**SSHAC Level 2 Questionnaire in Support of Cuba  
Hazard Sensitivity Calculations**

**NRC RAI Letter No. PTN-RAI-LTR-041**

Proposed Turkey Point Units 6 and 7  
Docket Nos. 52-040 and 52-041  
FPL Response to NRC RAI No. 02.05.01-22 (eRAI 6024)  
L-2013-236 Attachment 18 Page 15 of 15

**Figure 4 Fault Map of Cuba including Postulated Offshore Las Villas and Sierra de Jatibonico Faults from Reference 2**

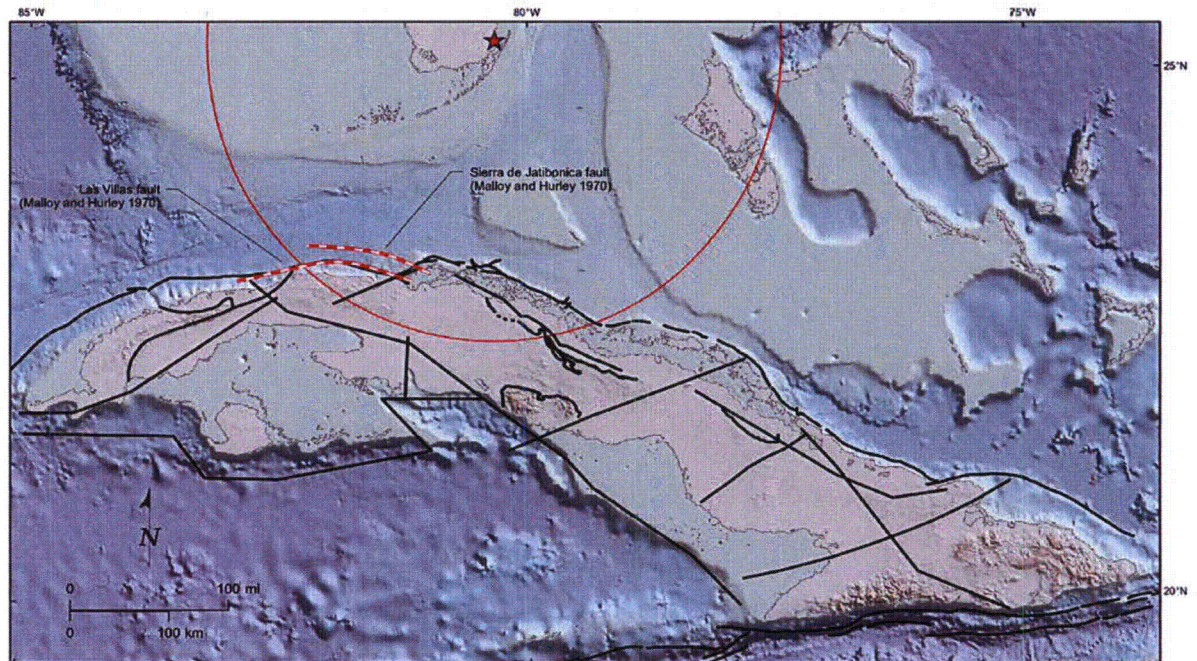
- a) Provide more detail from the Cotilla-Rodríguez et al. (2007) paper regarding the young eroded scarps of the Las Villas fault and specifically address Cotilla's conclusion that the fault is Pliocene-Quaternary in age.
- b) In the context of the chronology of geomorphic surfaces on Cuba, clarify the distinction between erosional processes that may have recently created "young" fault-line scarps along the Las Villas fault and Quaternary tectonic fault scarps.
- c) Discuss bathymetric evidence for the offshore location and recency of faulting along the Las Villas fault.
- d) Address the alignment of epicenters shown on Figure 2.5.1-267 along the Las Villas fault with respect to its tectonic activity. Please plot the uncertainties in event locations and include this information in the discussion.

Figure 4 is a map of faults in Cuba compiled for this project from various sources. This map shows Pardo's (FSAR Subsection 2.5.1, Reference 439) depiction of the Las Villas fault and Case and Holcombe's (FSAR Subsection 2.5.1, Reference 480) depiction of the Nortecubana fault as black lines. Additionally, this map shows Malloy and Hurley's (Reference 2) depictions of the postulated offshore Las Villas and Sierra de Jatibonico faults as red and white lines. As shown on Figure 4, Malloy and Hurley's (Reference 2) offshore Las Villas fault is roughly coincident with Case and Holcombe's (FSAR Subsection 2.5.1, Reference 480) Nortecubana fault between roughly Matanzas Bay and Havana. For this reason, it is assumed that Malloy and Hurley's (Reference 2) offshore Las Villas fault is a portion of what Case and Holcombe (FSAR Subsection 2.5.1, Reference 480) later mapped as the Nortecubana fault and that Malloy and Hurley's (Reference 2) offshore Las Villas fault is not the same structure as the Las Villas fault mapped by Pardo (FSAR Subsection 2.5.1, Reference 439), Cotilla-Rodriguez et al. (FSAR Subsection 2.5.1, Reference 494), Perez-Othon and Yarmoliuk (FSAR Subsection 2.5.1, Reference 848), Pushcharovskiy (FSAR Subsection 2.5.1, Reference 847), and others. As such, Reference 2 observations of possible bathymetric expression of the offshore Las Villas fault are assumed to be irrelevant for assessing the recency of movement on the mostly onshore Las Villas fault as defined by Pardo (FSAR Subsection 2.5.1, Reference 439) and others, but may be relevant for the Nortecubana fault.

Figure 1 Fault Map of Western Cuba Showing Earthquakes from the Phase 2 Earthquake Catalog

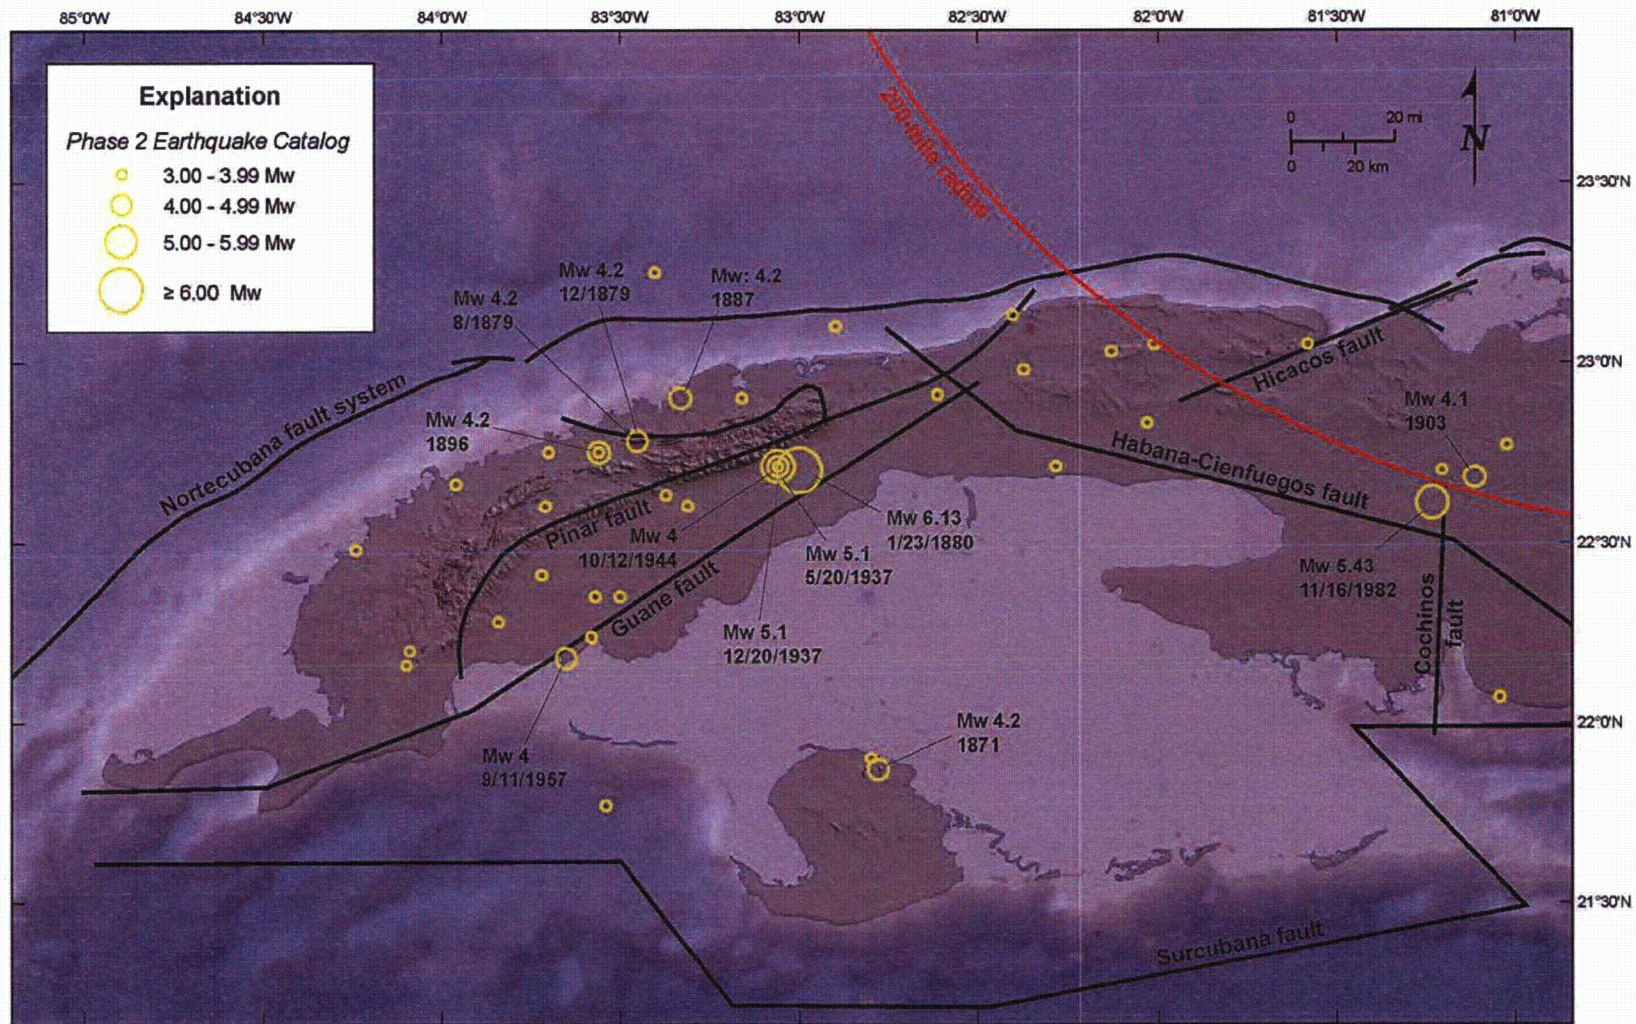
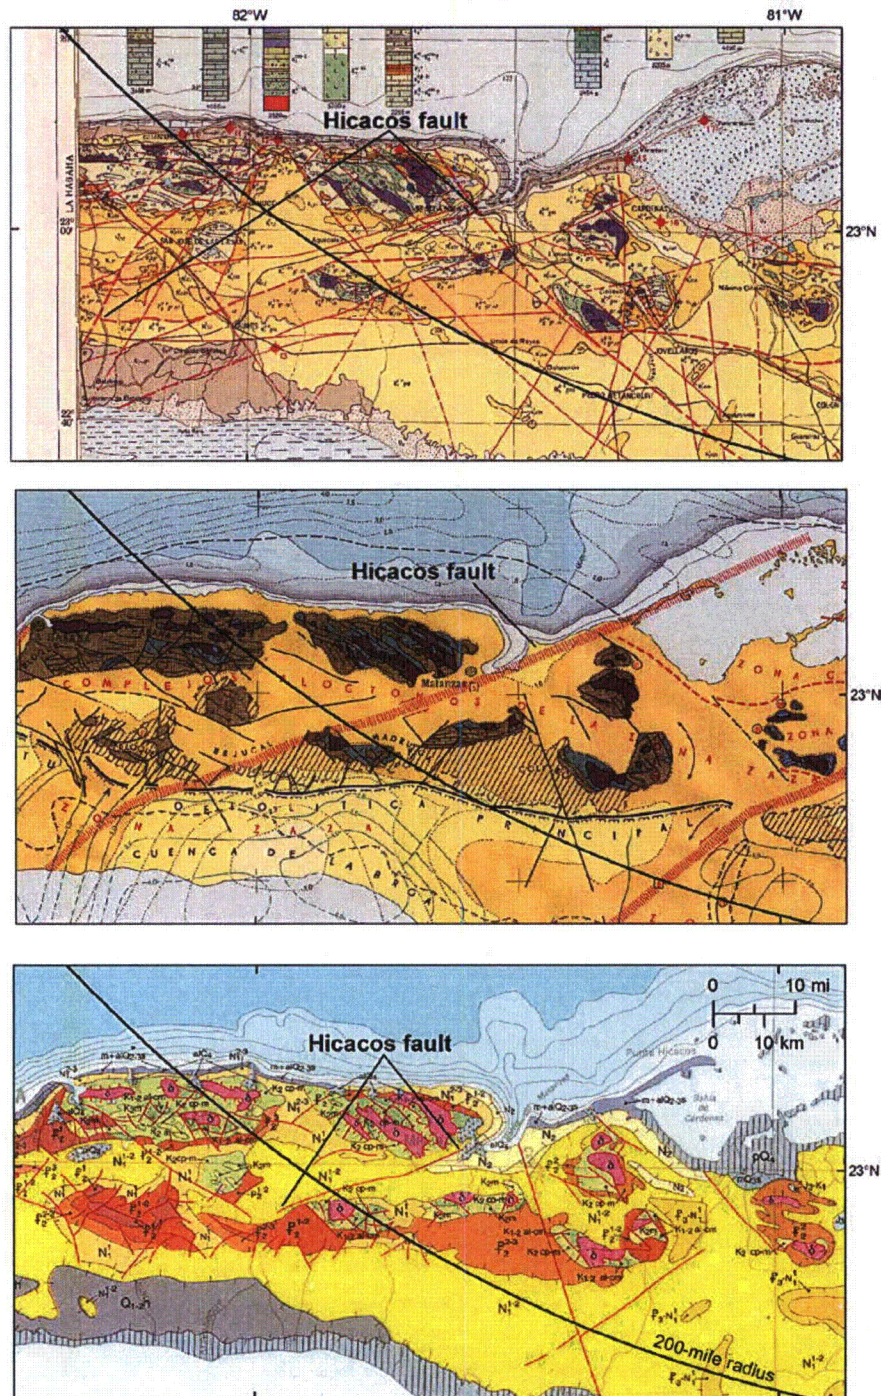
FSAR Figure 2.5.1-251, "Lithostratigraphic Map of Cuba", depicts the Matanzas fault zone within the site region; however, the staff notes that the Matanzas fault zone is not discussed in the FSAR.

The terms Matanzas fault and Hicacos fault refer to the same geologic feature. Most newer publications use the term Hicacos fault, and the FSAR follows this convention. The Hicacos fault is discussed in FSAR Subsection 2.5.1.1.1.3.2.4 and is shown in FSAR Figure 2.5.1-247. FSAR Figure 2.5.1-251 is a reproduction of Stanek et al.'s (2009) Figure 2 (FSAR Subsection 2.5.1, Reference 769), which labels this fault as Matanzas fault. The text of FSAR Subsection 2.5.1.1.1.3.2.4 and FSAR Figure 2.5.1-251 will be modified to indicate that Matanzas fault and Hicacos fault are two names for the same geologic feature. Figures 1 and 2 provide larger-scale maps of the Hicacos fault trace.

Case and Holcombe’s (1980) (FSAR Subsection 2.5.1, Reference 480) 1:2,500,000 scale map of the Caribbean region shows segments of the Hicacos fault cutting upper Tertiary rocks. Perez-Othon and Yarmoliuk’s (1985) (FSAR Subsection 2.5.1, Reference 848) 1:500,000 scale geologic map of Cuba shows an unnamed fault in the vicinity of the Hicacos fault that extends from Matanzas for approximately 50 miles (80 kilometers) to the southwest (upper panel of Figure 2). Because they do not label faults by name, it is not clear whether the Hicacos fault is depicted on Perez-Othon and Yarmoliuk’s (1985) (FSAR Subsection 2.5.1, Reference 848) inset map of fault ages in Cuba. However, they indicate a Mesozoic age for an unnamed fault in the vicinity of the northeastern-most portion of the Hicacos fault. Pushcharovskiy et al.’s (1988) (FSAR Subsection 2.5.1, Reference 846) 1:250,000 scale geologic map of Cuba shows an unnamed fault cutting lower Miocene rocks in the vicinity of the central Hicacos fault, but their mapping does not extend this fault as far northeast as the north coast of Cuba. However, the locally northeast-trending shoreline and a narrow peninsula near Matanzas are notably linear and on-trend with the fault, likely influencing where the fault is mapped in other representations. Pushcharovskiy’s (1989) (FSAR Subsection 2.5.1, Reference 847) 1:500,000 scale tectonic map of Cuba shows the northeastern extent of the Hicacos fault similar to the depiction shown in Figure 1 that terminates to the southwest at Cuba’s southern coast (middle panel of Figure 2).
